Gallanes Amenity Area (Phase 2)

Road Safety Audit Stage 1/2

<b>Client</b>	Cork County Council
<b>Project Title</b>	Gallanes Amenity Area (Phase 2)
<b>Project Location</b>	Clonakilty, Co. Cork
<b>Document Title</b>	Road Safety Audit Stage 1/2
<b>Document No.</b>	MHL-21119TT-GALLANES-DOC02-RSA
<b>Job No.</b>	21199TT

**Figure 4.1 Audit location**

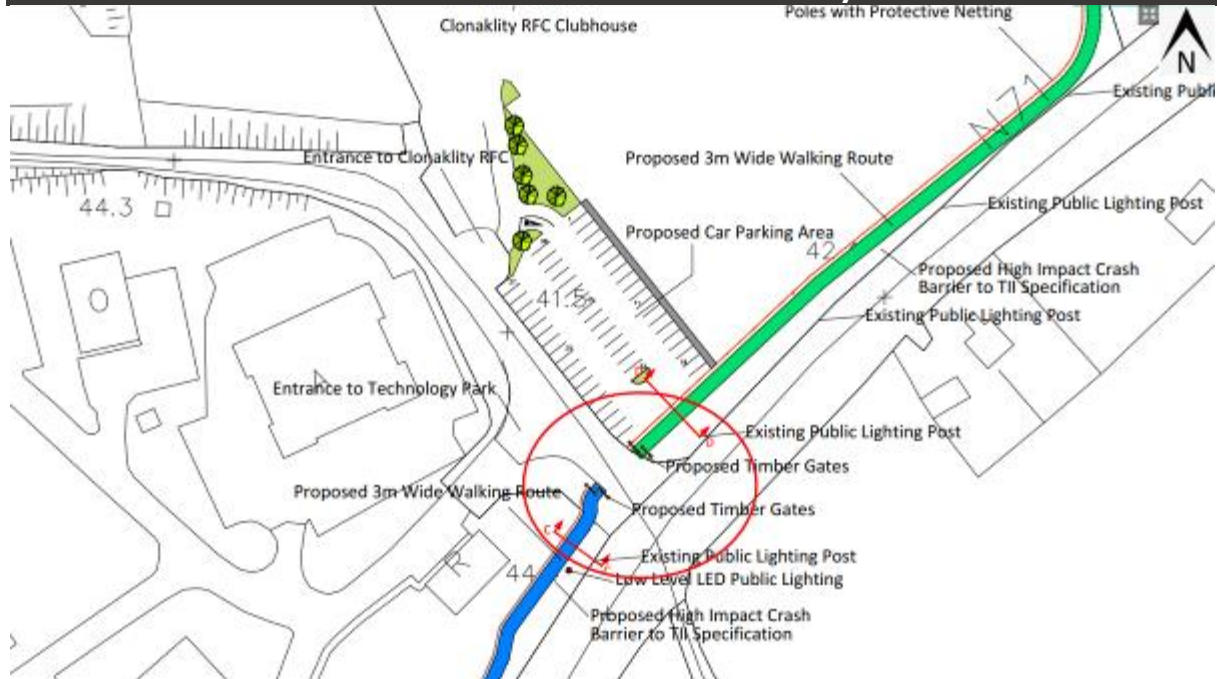
Existing visibility splays at the N71 junction should not be hindered by any pedestrian crossing proposals. Failure to provide appropriate visibility at the junction may lead to collisions between passing vehicles and vehicles exiting the junction. See Photos A3 and A4 in Appendix A.

It is unclear if the proposed lighting is adequate to properly light the tie in location across the existing junction entrance. Failure to adequately illuminate the proposed junction may lead to collisions involving vehicles and pedestrian amenity walkers.

It is unclear if the existing lighting columns as shown in the layouts are to remain in their current locations or are to be repositioned to account for the new amenity walkway. Failure to provide appropriate column offset locations may lead to collisions involving passing vehicles.

It is unclear if the amenity car parking area is to be illuminated. Failure to provide appropriate lighting locations may lead to collisions involving passing vehicles and vulnerable road users.

No pedestrian connection between the amenity walkway and the proposed amenity car park is shown in the design layouts. Failure to provide appropriate pedestrian access to this carpark may lead to collisions involving vehicles and pedestrians travelling to/from the site along the L4032.

It is unclear from the layouts what boundary treatment is proposed along the section of amenity walkway that runs adjacent to the Rugby Club. Failure to provide appropriate boundary treatment provision may lead to trip/fall hazards to pedestrians travelling to/from this pedestrian route.

The design layouts do not show what drainage proposals are to be provided. The addition of the new hardstand areas in the form of footpaths may lead to standing roadside water, possibly leading to aquaplaning on the road and in the vicinity of the proposed crossings. This may lead to collisions between passing vehicles and crossing pedestrians.

The design layouts do not show what traffic sign proposals are to be provided. The addition of the pedestrian crossing will lead to greater interaction between vulnerable road users and vehicle traffic. In appropriate signage may lead to collisions between passing vehicles and crossing pedestrians.

The design layouts call up vehicle impact restraint system to run the length of the proposed amenity walkway that abounds the N71. It is unclear the type of containment proposed and its appropriateness for the N71.

During the site visit, the daily Bus Eireann 237 service that passes the site was seen to stop directly at the N71/L4032 junction, creating a traffic hazard. This is noted in Photo A5. This led to diminished sightlines for existing traffic onto the N71 and unsafe pedestrian movements along the N71 carriageway road edge.

Existing visibility splays at the Clonakilty Rugby Football Club junction should not be hindered by any pedestrian crossing proposals, boundary treatment proposals or proposed amenity parking facilities. Failure to provide appropriate visibility at the junction may lead to collisions between passing vehicles and vehicles exiting the junction. See Photos A3 and A4 in Appendix A.

It is unclear if the sufficient forward visibility of approaching cars to the new pedestrian crossing is provided. Failure to provide appropriate forward visibility of the pedestrian crossing may lead to collisions between vehicles and vulnerable users at this location. See Photos A3 and A4 in Appendix A.

The proposed layouts do not show tactile paving at the proposed pedestrian crossing location. Failure to provide appropriate tactile paving may lead to visually impaired/vulnerable users walking onto the road carriageway. This could lead to collisions between vehicles and vulnerable users at this location. See Photos A3 and A4 in Appendix A.

Provide appropriate junction offset for any pedestrian crossing proposals, inclusive of enforcement road markings with traffic management buildouts and double yellow road marking in the vicinity of the entrance to ensure that appropriate visibility is provided.

Review the public lighting design in the vicinity of the proposed entrance junction to ensure compliance with relevant design standards. Provide appropriate public lighting for at the pedestrian crossing and pedestrian pathways.

Review the existing public lighting design along this section of amenity walkway to ensure compliance with relevant design standards. Provide appropriate public lighting column offsets for the scheme.

Review the existing public lighting design at this section of amenity walkway to ensure compliance with relevant design standards. Provide appropriate public lighting design to relevant standards.

Provide appropriate pedestrian connectivity from the pedestrian route to the proposed amenity car park, ensuring compliance with relevant design standards.

Provide appropriate boundary treatment provision along pedestrian walkway, ensuring compliance with relevant design standards.

Provide appropriate surface water drainage ensuring that existing roadside drainage is not impeded.

Provide appropriate traffic signage as per the Traffic Signs Manual.

Provide appropriate vehicle impact restraint system to the appropriate containment level for a 100kph National Secondary carriageway. Ensure appropriate vehicle offset between the restraint system is provided for the length of the proposed pedestrian walkway, ensuring compliance with relevant design standards.

Provide appropriate bus set down facilities at this location to service the Business/Technology Park and rugby club, ensuring compliance with relevant design standards.

Provide appropriate setback of the car parking spaces from the rugby club boundary with the local road, ensuring junction visibility splay envelopes at the RFC entrance are appropriate to the relevant design speed.

Provide appropriate forward sightlines on all approach arms to the junction, ensuring crossing pedestrians can be clearly seen from the appropriate FSD.

Provide appropriate junction tactile paving on both sides of the junction.

**Figure 5.1 Audit location**

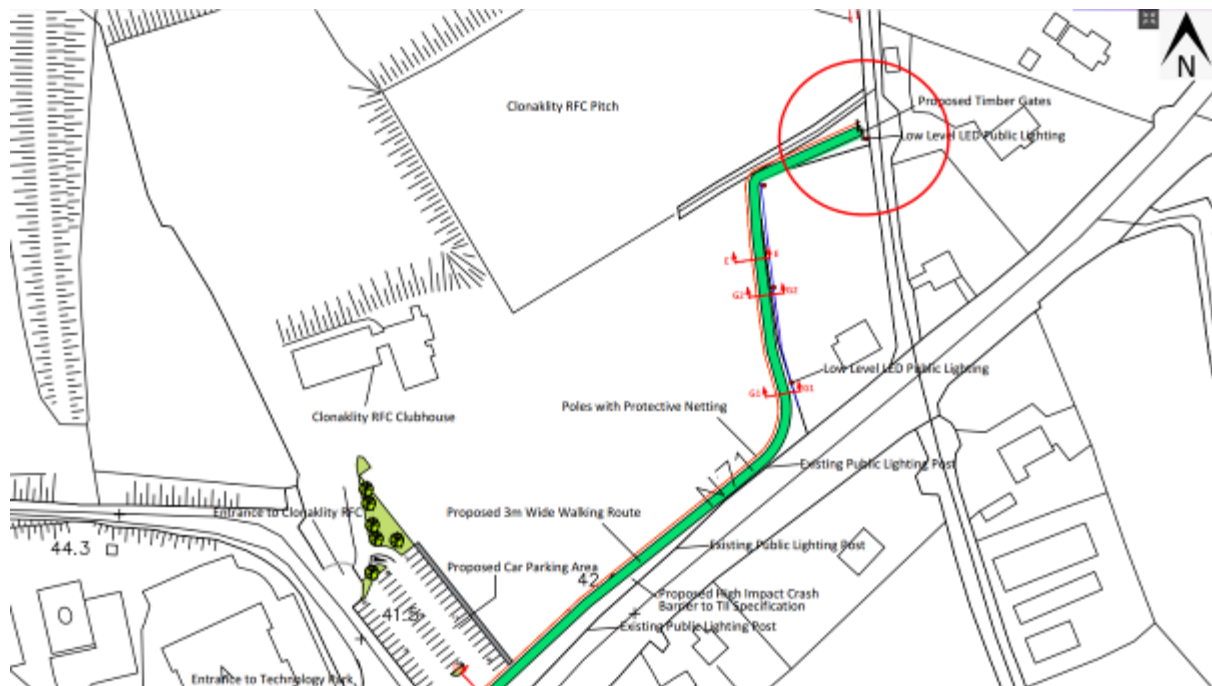
It is unclear if the proposed lighting is adequate to properly light the tie in location across the existing residential junction entrance. Failure to adequately illuminate the proposed junction may lead to collisions involving vehicles and pedestrian amenity walkers.

It is unclear from the layouts what boundary treatment is proposed along the section of amenity walkway that runs adjacent to the Rugby Club. Failure to provide appropriate boundary treatment provision may lead to trip/fall hazards to pedestrians travelling to/from this pedestrian route. See Photos A7, A8 and A9 in Appendix A.

The design layouts do not show what drainage proposals are to be provided. The addition of the new hardstand areas in the form of footpaths may lead to standing roadside water, possibly leading to aquaplaning on the road and in the vicinity of the proposed crossings. This may lead to collisions between passing vehicles and crossing pedestrians.

The design layouts do not show what protective netting proposals are to be provided. Failure to provide appropriately design protective netting in terms of capture height and netting mesh size may lead to errant balls entering onto the N71, which could lead to collisions between passing vehicles.

It is unclear if the mature line that currently lines the boundary between the N71 and the Clonakilty RFC is to be removed. The existing mature trees block pitch flood lighting from entering onto the adjoining N71 carriageway. Failure to take account of obtrusive flood lighting dazzling passing traffic may lead to traffic collisions. See Photo A7 in Appendix A.

It is unclear what design provision is to be installed at the connection with the cul de sac road, to the east of the site extents. The local road is narrow and could become a location for uncontrolled parking. Failure to take account of uncontrolled parking may lead to traffic collisions.

Review the public lighting design in the vicinity of the proposed entrance junction to ensure compliance with relevant design standards. Provide appropriate public lighting for the scheme. Provide adequate lighting at pedestrian crossings and isolated pedestrian pathways.

Provide appropriate boundary treatment provision along pedestrian walkway, ensuring compliance with relevant design standards.

Provide appropriate surface water drainage ensuring that existing roadside drainage is not impeded.

Provide appropriate netting proposals ensuring that errant rugby balls are captured before entering onto the National Secondary Road carriageway.

Review the existing public lighting design/lanterns installed for the rugby pitch to ensure obtrusive lighting is mitigated and compliance with relevant design standards is maintained.

Provide parking control measures in the form of lining and signage on the cul de sac road.
